# Transpower's individual price-quality path from 1 April 2020

## Draft decisions and reasons paper

**Date of publication:** 29 May 2019

Commerce Commission  
Wellington, New Zealand

**Figure F6 AP2 – % Availability of HVAC**

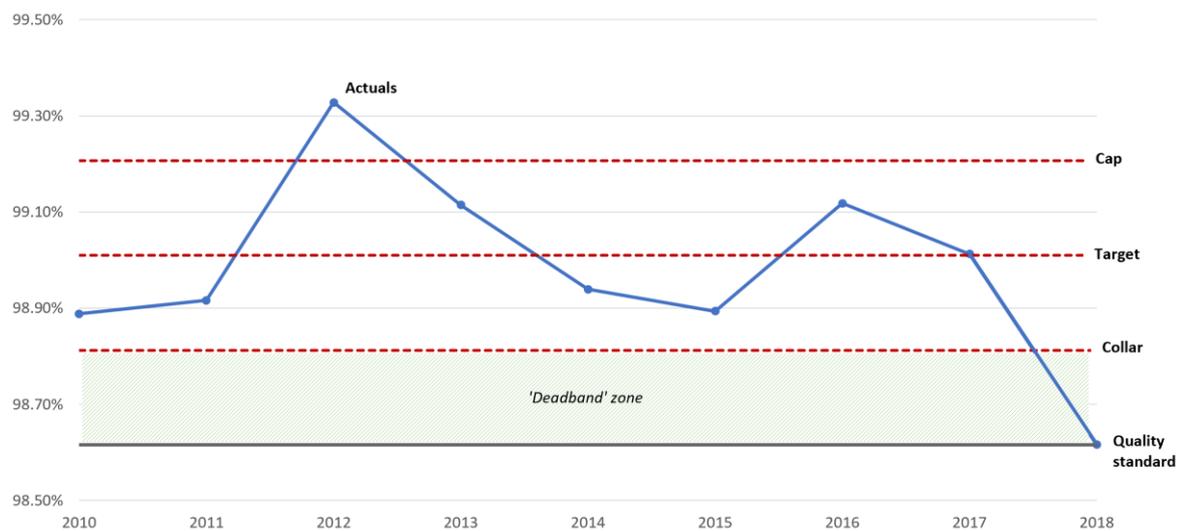
F180 Figure F6 illustrates how our proposed AP2 incentive measures (cap, collar and target) and quality standard compare against Transpower’s historical performance.

**Figure G1 Transpower estimate of SA Protection, Station DC systems and Revenue Metering capex for RCP2 to RCP5<sup>333</sup>**

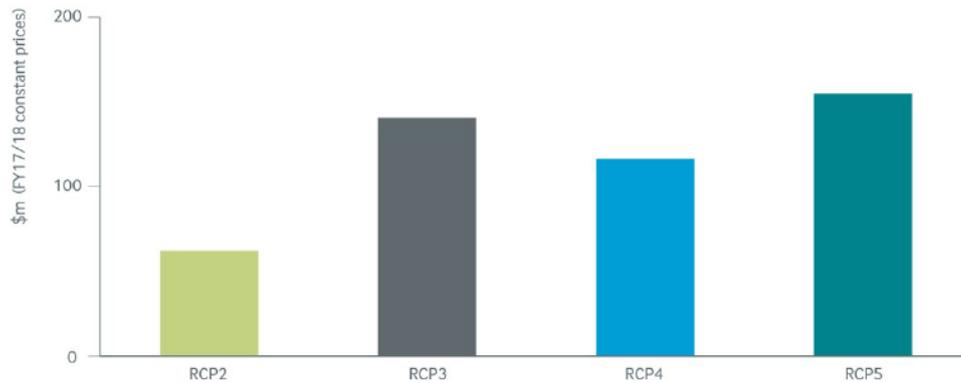
G108 We were guided by the Verifier analysis that indicated that Transpower was about to face a “bow-wave” of replacements in this asset category (see Figure G1). Transpower’s Asset Management Plan illustrates the Verifier conclusion and Transpower stated that the RCP3 expenditure uplift is largely due a “general wave of replacements coming due as they reach end-of-life. For example, the expenditure on lifecycle replacement of revenue meters in RCP3 is \$53.7m”.<sup>332</sup>

**Figure G2 Total ICT capex from RCP1 to RCP5<sup>350</sup>**

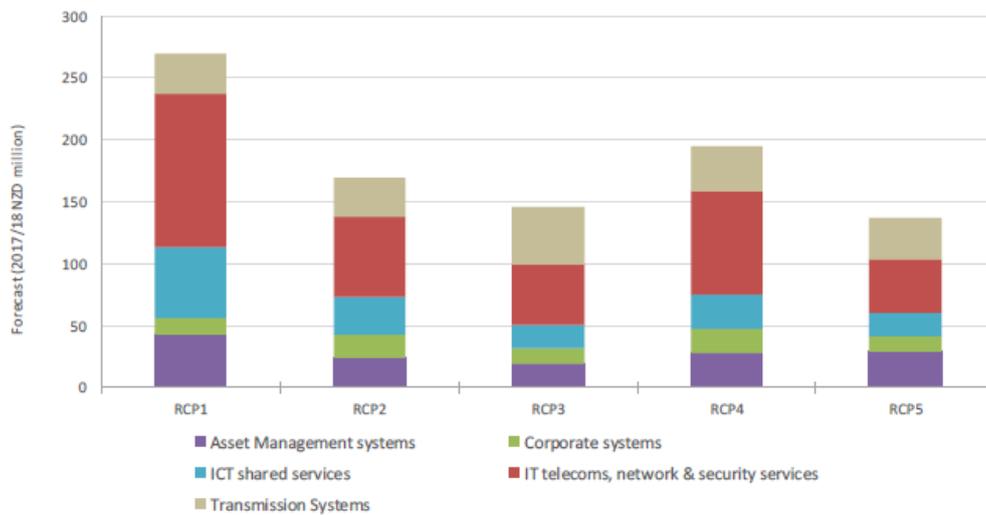
G163 The total proposed programme is \$146.1m in RCP3 compared with \$169.5m in RCP2. Figure G2 illustrates the proposed RCP3 ICT capex when compared with previous periods and Transpower’s prediction for RCP4 and RCP5.
